**PCN 20140728001
20x20x1.4 LQFP tray change
Information Only**

PCN Number:	20140728001			PCN Date:	08/12/2014
Title:	20x20x1.4 LQFP tray change				
Customer Contact:	PCN Manager		Phone:	+1(214) 480-6037	Dept: Quality Services
Change Type:					
<input type="checkbox"/> Assembly Site	<input type="checkbox"/> Design	<input type="checkbox"/> Wafer Bump Site	<input type="checkbox"/> Assembly Process	<input type="checkbox"/> Data Sheet	<input type="checkbox"/> Wafer Bump Material
<input type="checkbox"/> Assembly Materials	<input type="checkbox"/> Part number change	<input type="checkbox"/> Wafer Bump Process	<input type="checkbox"/> Mechanical Specification	<input type="checkbox"/> Test Site	<input type="checkbox"/> Wafer Fab Site
<input checked="" type="checkbox"/> Packing/Shipping/Labeling	<input type="checkbox"/> Test Process	<input type="checkbox"/> Wafer Fab Materials			<input type="checkbox"/> Wafer Fab Process

Texas Instruments Incorporated is announcing an information only notification for 20x20x1.4 LQFP tray change from Supplier Ohkawa or Supplier Peak to Supplier UBoT.

DIMENSIONAL COMPARISON

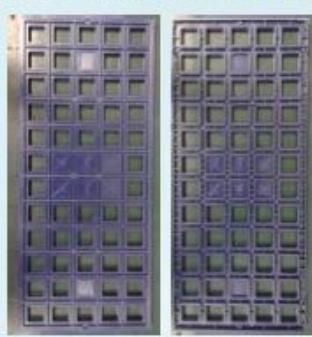
- As per dimensional analysis, the difference is the top package seating height and cavity size.

ACTUAL APPEARANCE:

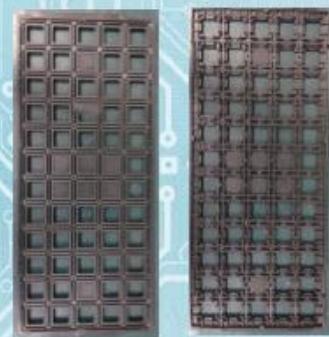
Appearance is almost the same as the current tray. The only difference is the color and rounded fence.
